SUBJECT: CERTIFICATION OF THE MINUTES OF THE ACRS SUBCOMMITTEE  
MEETING ON THE OYSTER CREEK GENERATING STATION LICENSE  
RENEWAL APPLICATION, JANUARY 18, 2007 - ROCKVILLE,  
MARYLAND

**ADVISORY COMMITTEE ON REACTOR SAFEGUARDS  
MINUTES OF ACRS PLANT LICENSE RENEWAL SUBCOMMITTEE MEETING  
OYSTER CREEK GENERATING STATION  
JANUARY 18, 2007  
ROCKVILLE, MARYLAND**

On January 18, 2007, the Plant License Renewal Subcommittee held a meeting in Room T2B3, 11545 Rockville Pike, Rockville, Maryland, to review the License Renewal Application (LRA) for the Oyster Creek Generating Station (OCGS) and the associated Safety Evaluation Report (SER) with Open Items.

# Drywell Model – Elevations and Regions

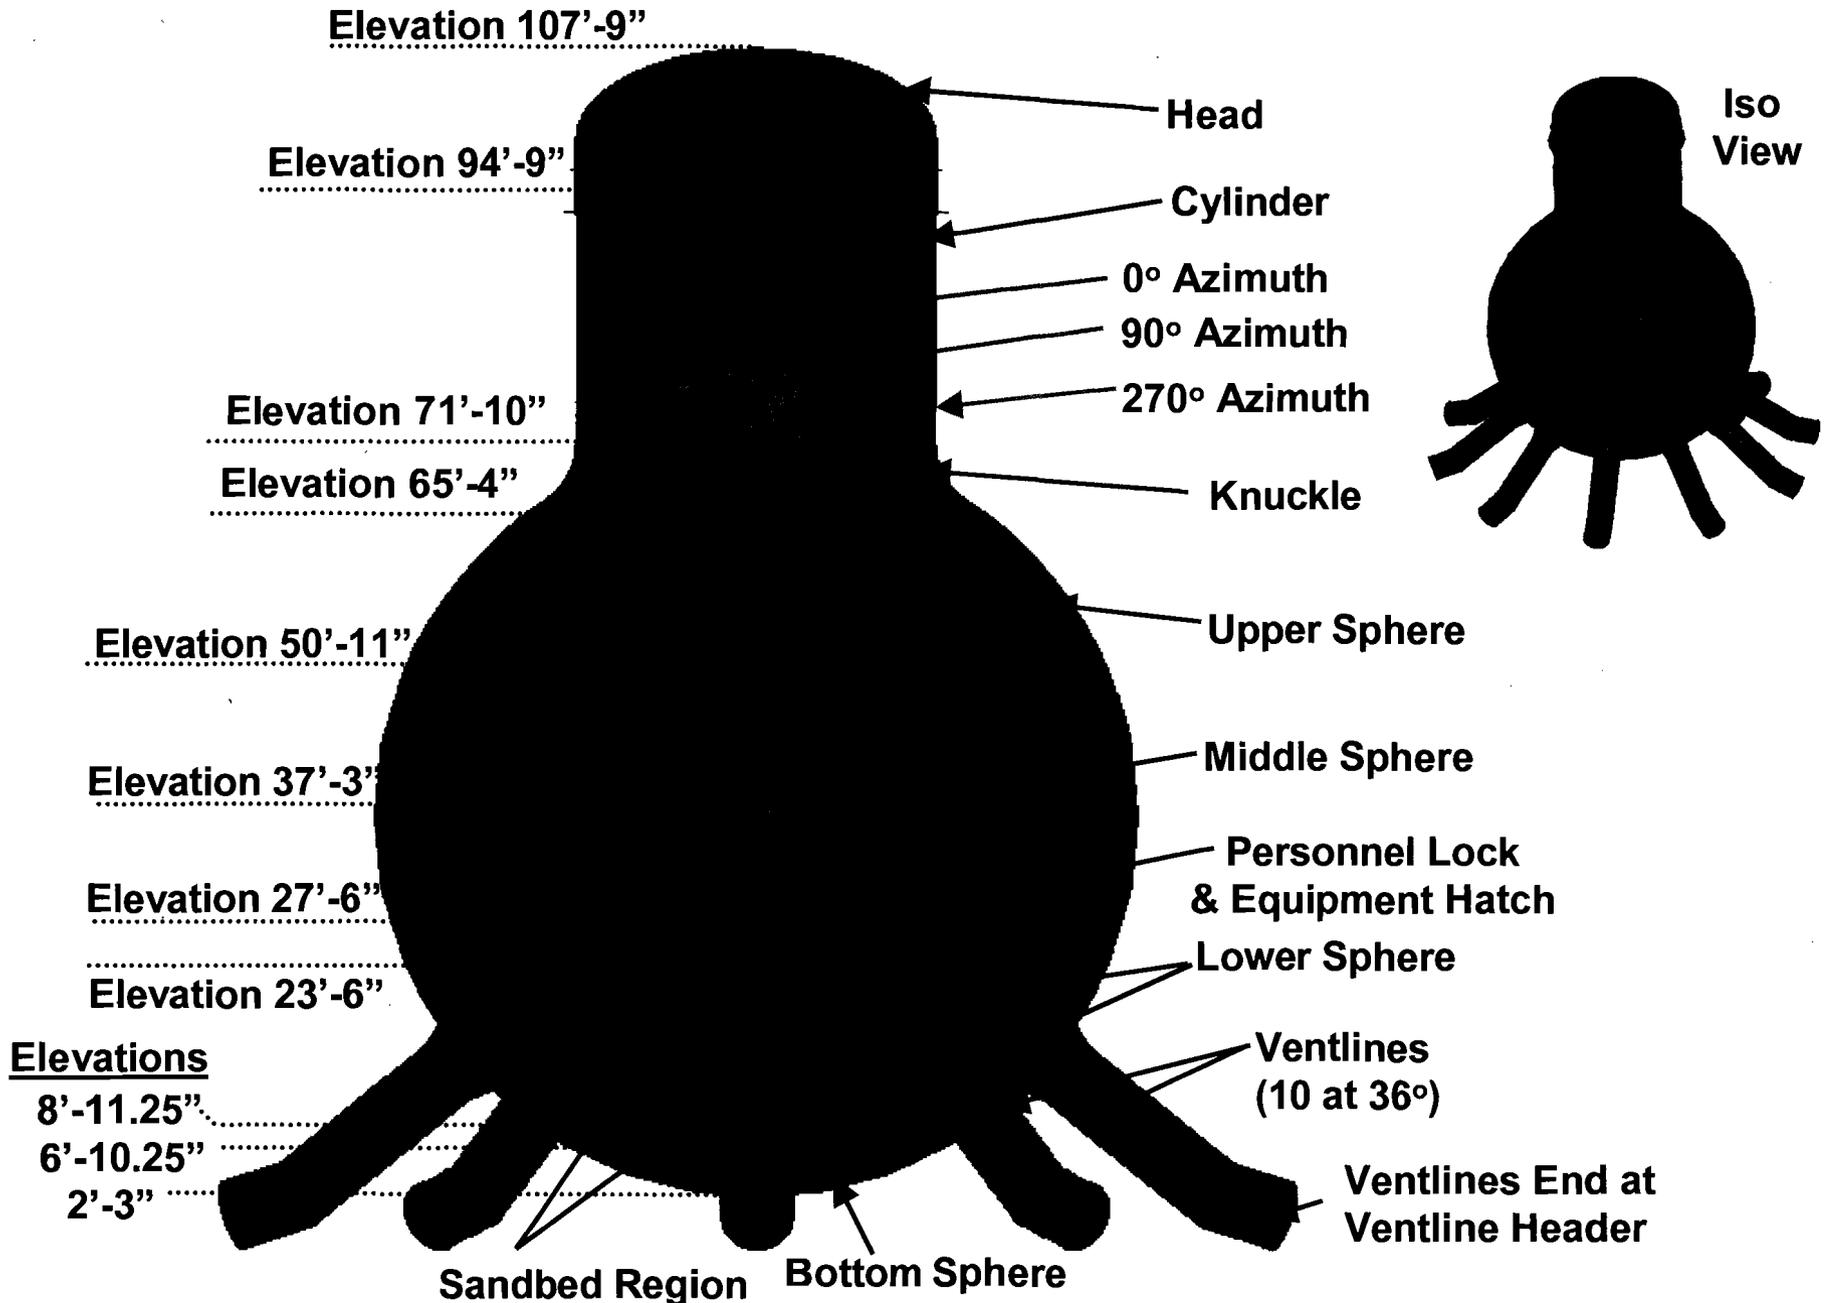
- **OI 4.7.2-1.3:** Buckling Analysis: Question on the appropriateness of certain technical assumptions in AmerGen's analysis of the potential for "buckling" of the drywell shell

3. In RAI 4.7.2-1 dated March 10, 2006, the staff requested that the applicant provide the following information: A summary of the factors considered in establishing the minimum required drywell thickness. On further evaluation of the applicant's information, the staff concluded that the stability evaluation was consistent with the guidelines of ASME Code Case N-284-1. The staff's concern about use of the same section strength across the corroded section of the shell is addressed by Code Case N-284-1, which uses conservative assumptions to determine shell capacity reduction factors (i.e., assumption of imperfection limit indicated by parameter "e/t" to be 1.0 in the code case) expected to compensate reasonably for such use of the same section strength. In addition, the applicant conservatively assumed the local corroded thickness for the entire drywell shell region and demonstrated that the code-allowable stresses were satisfied consistently with the guidelines of the code case. Thus, this analysis adds a margin of safety for the drywell stability evaluation. On this basis, the staff believes that the stability evaluation method is adequate and acceptable, and the staff's concern is resolved. Open Item 4.7.2-1.3 is closed.
